**GLEN ACRES, 1<sup>ST</sup> ADDITION, BLOCK A,**  
**RESUBDIVISION OF LOTS 4, 5, 6, 7, 8, & 9**

APPLICATION NUMBER 10 DATE May 18, 2006

REQUEST Subdivision

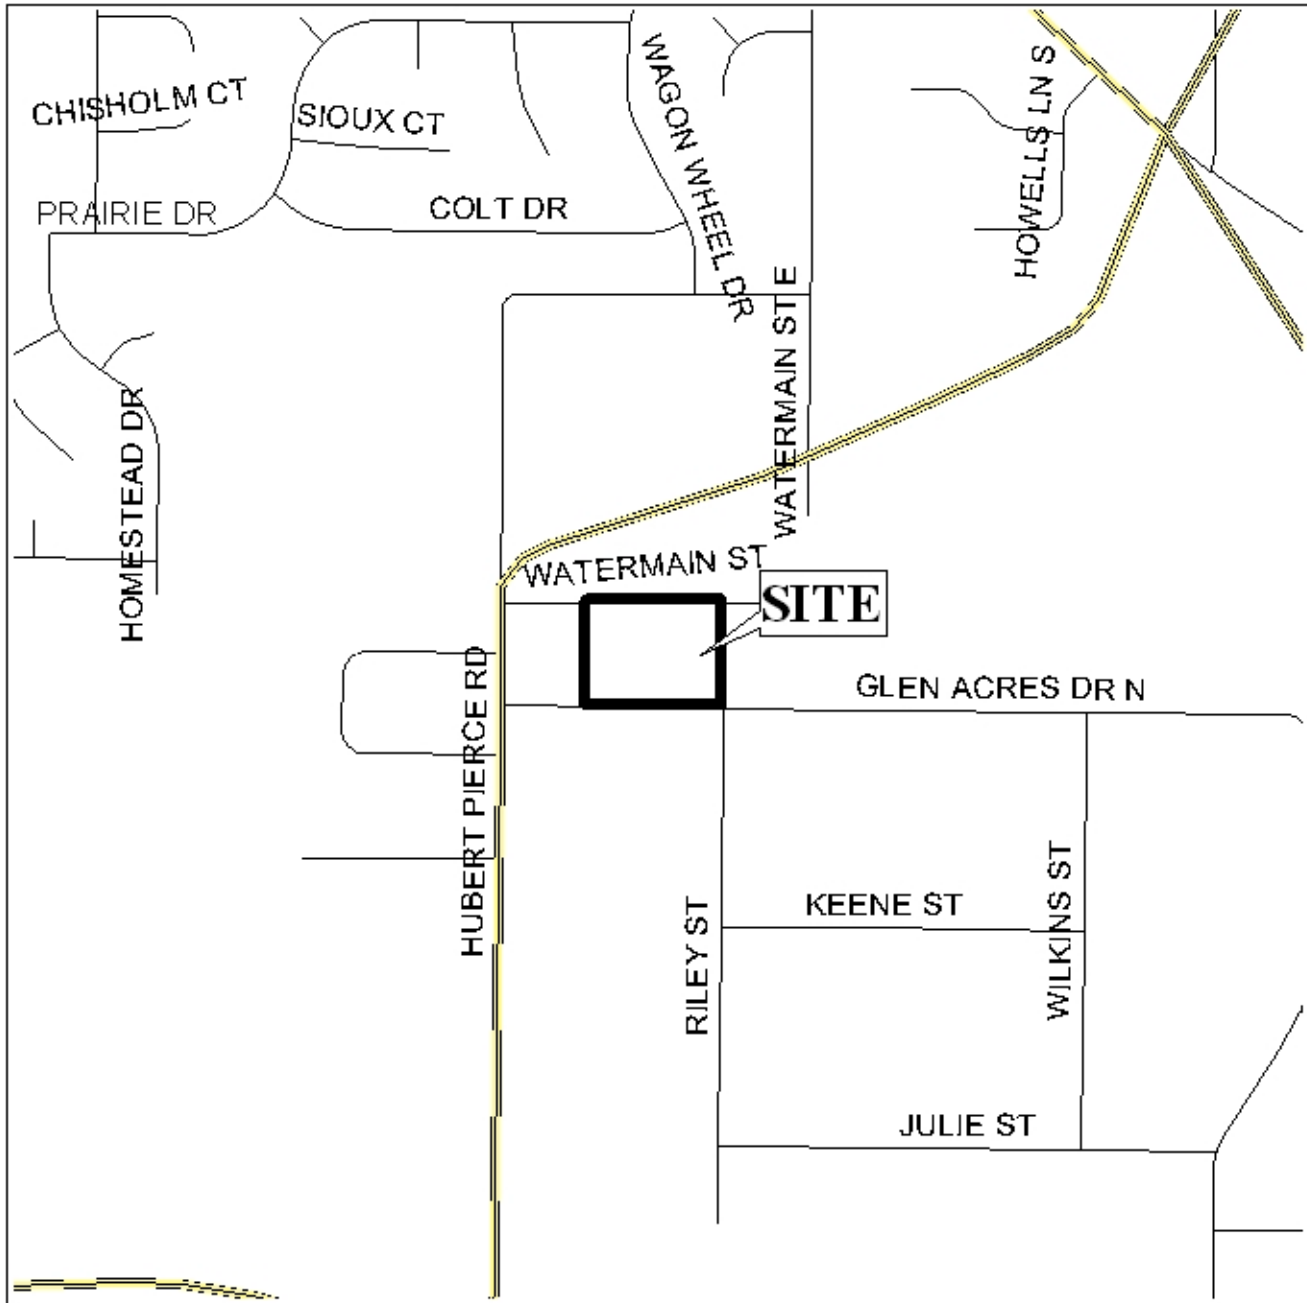
The site fronts Glen Acres Drive North, which has a 50-foot right-of-way. Additionally, as illustrated on the Vicinity Map Watermain Street, which is a prescriptive right-of-way connecting with Hubert Pierce Road, this is located at the rear property line of Lot 1 of the proposed subdivision. Based on staff research the traveled roadway is no wider than 20-feet from Hubert Pierce Road to the site. This prescriptive right-of-way is essentially a dirt road that is graded frequently by the County. It is the practice of the Planning Commission to deny applications that would increase the number of lots on substandard (dirt) roads. However, the current application would not require access from Watermain Street; therefore, Lot 1 should be denied access to Watermain Street. Moreover, it has been the practice by County Engineering to require dedication of sufficient right-of-way of 30-feet along each side of the centerline of the existing traveled roadway.

The plat does not show the 25-foot front building setbacks, which will be required on the final plat.

The plat meets the minimum standards of the Subdivision Regulations and is recommended for Tentative Approval subject to the following conditions: 1) the placement of a note on the final plat stating that access to Watermain Street (prescriptive right-of-way) be denied; 2) dedication of sufficient right-of-way of 30-feet along each side of the centerline of the traveled roadway; 3) the placement of a note on the final plat stating that any lots that are developed commercially and adjoin residentially developed property must provide a buffer, in compliance with Section V.A.7 of the Subdivision Regulations; and 4) the placement of the 25-foot minimum building setbacks on the final plat.
